ARKANSAS NUCLEAR ONE - UNIT 1

IMPROVED TECHNICAL SPECIFICATIONS SUBMITTAL

**05/01/01 Supplement
Volume 2 of 2
(Sections 3.7 and 3.8)**

May 1, 2001

Figure 3.8.1

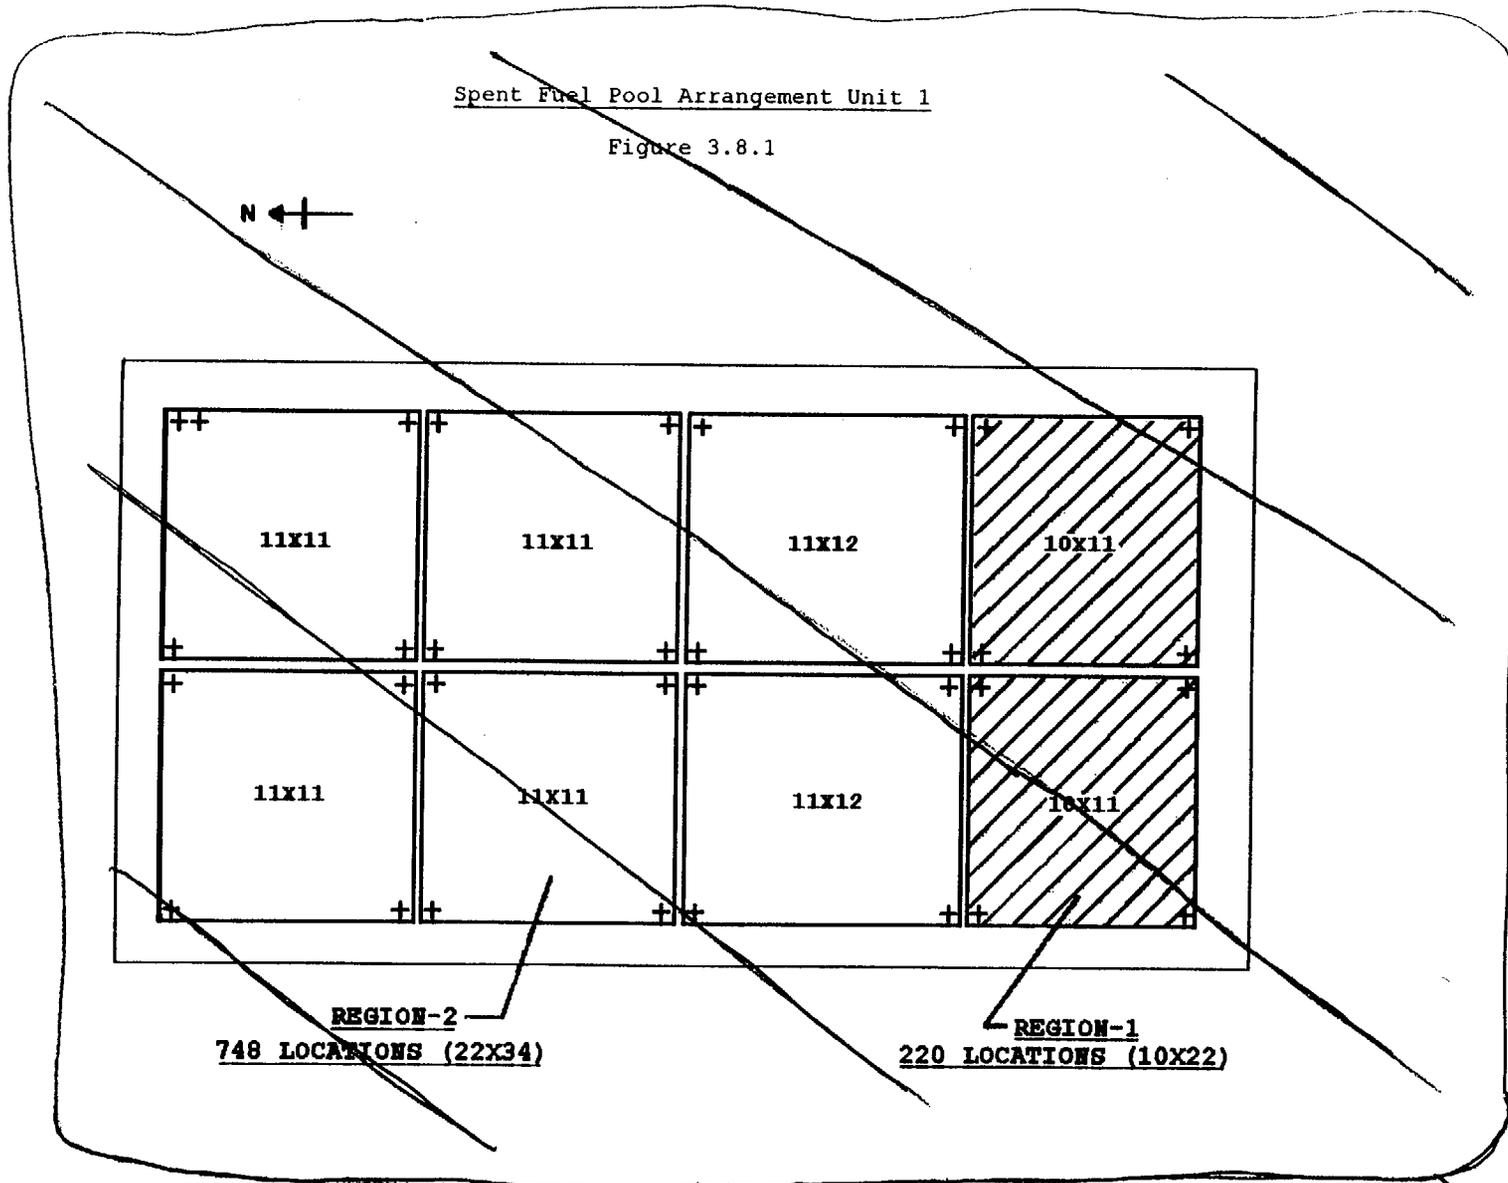
~~3.8.16 Storage in Region 2 (as shown on Figure 3.8.1) of the spent fuel pool shall be further restricted by burnup and enrichment limits specified in Figure 3.8.2. In the event a checkerboard storage configuration is deemed necessary for a portion of Region 2, vacant spaces adjacent to the faces of any fuel assembly which does not meet the Region 2 burnup criteria (non-restricted) shall be physically blocked before any such fuel assembly may be placed in Region 2. This will prevent inadvertent fuel assembly insertion into two adjacent storage locations. The provisions of Specification 3.0.3 are not applicable.~~ (LA3) SAR
(LA1) Bases

<u>CTS Location</u>	<u>New Location</u>
3.7-31 Figure 3.8.1	SAR Fig. 9-53
3.7-15 Table 4.1-3, #4 w/Note (9)	TRM
3.7-19 4.5.1.1.2 (b)	TRM
4.5.2.1.2 (c) (3)	TRM
3.7-21 4.11.5	TRM
